Addendum, Change Order, Drawing, Deferred Approval Worksheet and Transmittal Memo

**EVALUATION AND DESIGN CRITERIA REPORT
REVISION 3
DSA BACKCHECK**

BERKELEY CITY COLLEGE

KPW Project No 16C129
DSA APPLICATION #01REH-10075

Markup for material testing scope of work
By LZD of KPW
3/1/17
R1 Markup 12/19/17
Ref. REH Report Material Testing Comments
R2 Markup 6/22/18
Ref. DSA comments received 3/27/18
R3 Markup 8/7/18 for DSA Approval

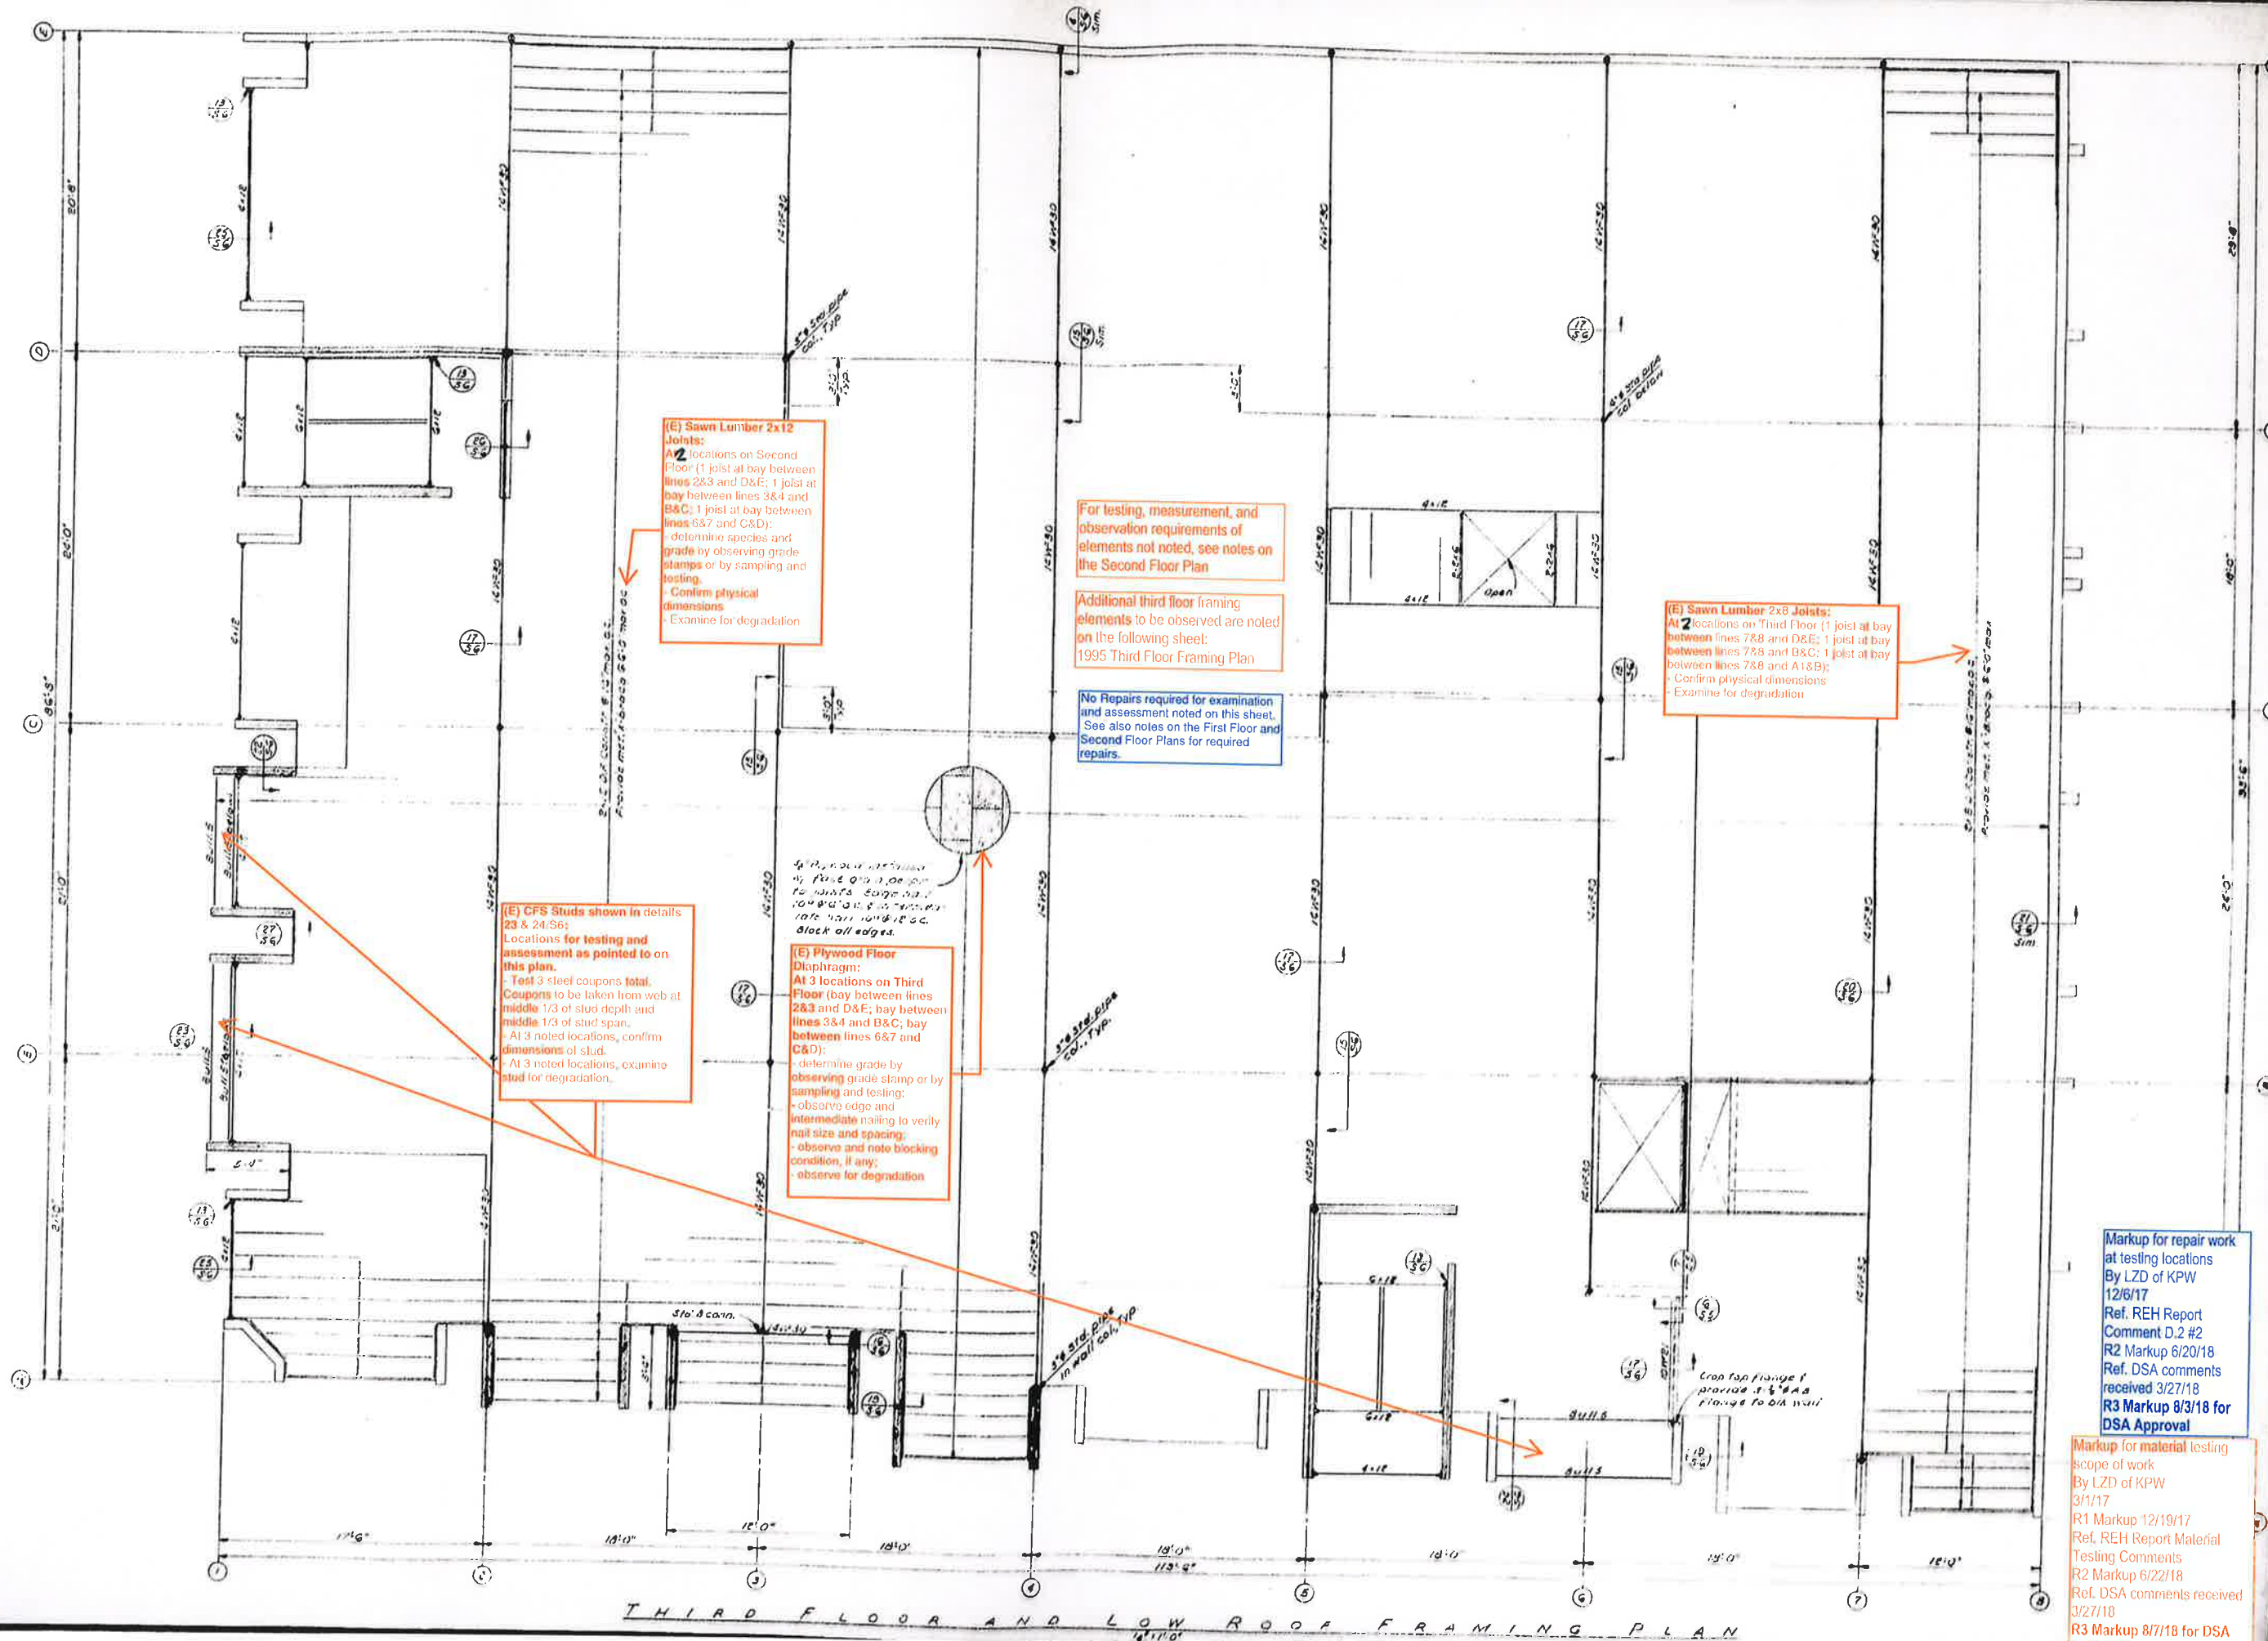
(E) CFS Slabs shown in details 23 & 24:
Locations for testing and assessment as pointed to on this plan.
- Test 3 steel coupons total. Coupons to be taken from web at middle 1/3 of stud depth and middle 1/3 of stud span.
- At 3 noted locations, confirm dimensions of slab.
- At 3 noted locations, examine slab for degradation.

(E) Wall Ties - Repairs at Test Locations:
- Replace damaged CMU block per 1/R-S1.01
- Replace bolts with epoxy bolts of same size and embed at removed bolts per 6/R-S1.01 similar. Tension test per general notes.

Markup for material testing scope of work
By LZD of KPW
3/1/17
R1 Markup 12/19/17
Ref. REH Report Material Testing Comments
R2 Markup 6/22/18
Ref. DSA comments received 3/27/18
R3 Markup 8/7/18 for DSA approval.

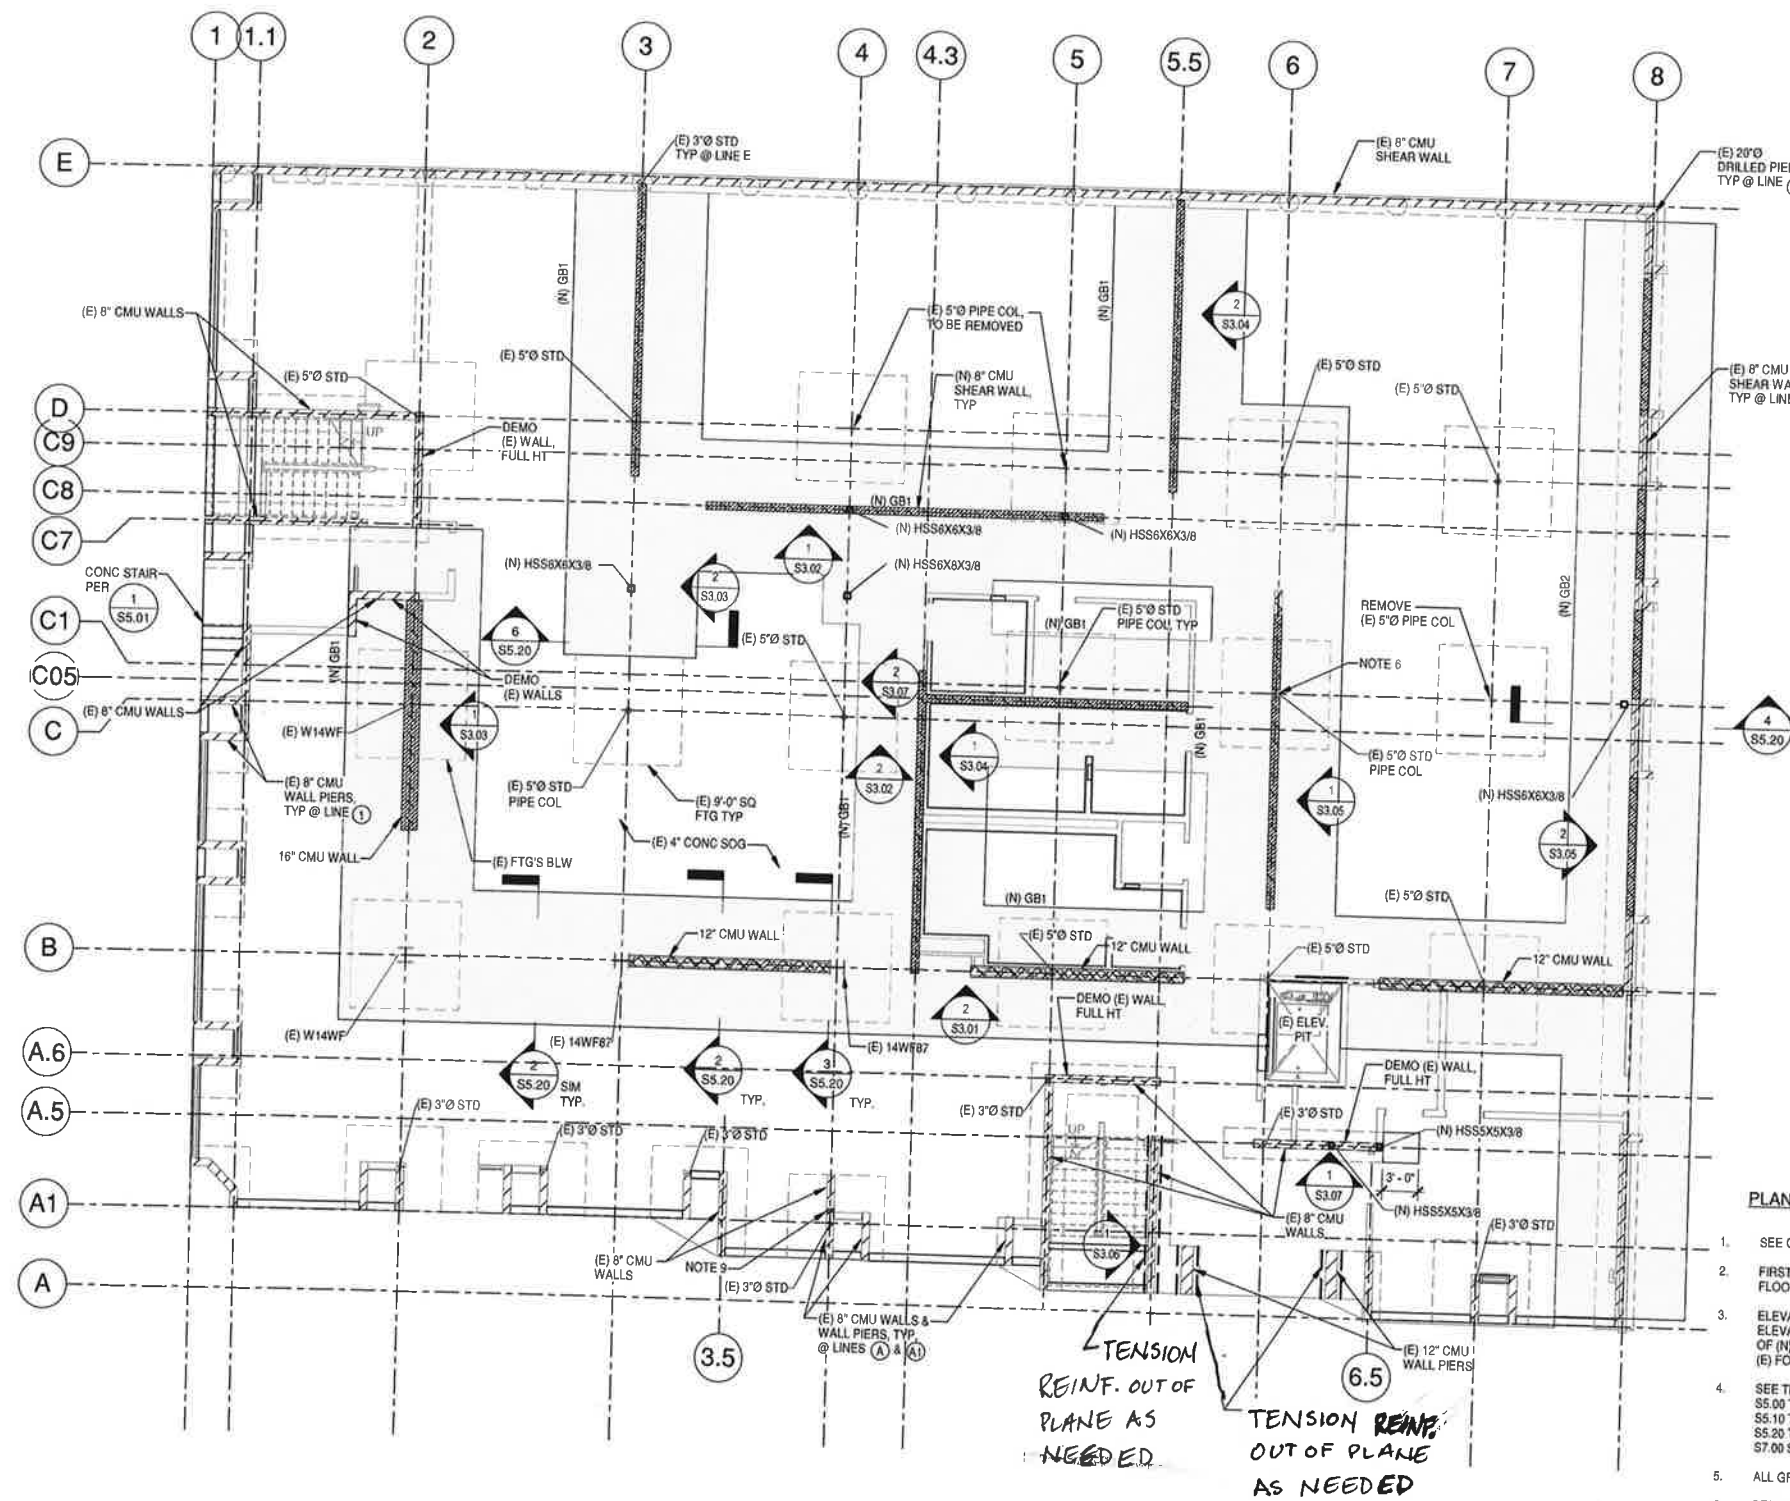
(E) CMU Wall - Line 8:
- Use nondestructive testing (per Data Collection text) at midheight of 2nd floor pilaster to determine size of CMU blocks, extent of grouting, size and spacing of reinforcement (all bars noted in the pilaster section detail), and location and length of pilaster vertical reinforcement splices.

(E) CMU Wall - Line 8:
- Use nondestructive testing (per Data Collection text) at 2nd floor spandrel to determine size of CMU blocks, extent of grouting, size and spacing of typical pier horizontal and vertical bars and added beam horizontal bars, and location and length of beam horizontal reinforcement splice.
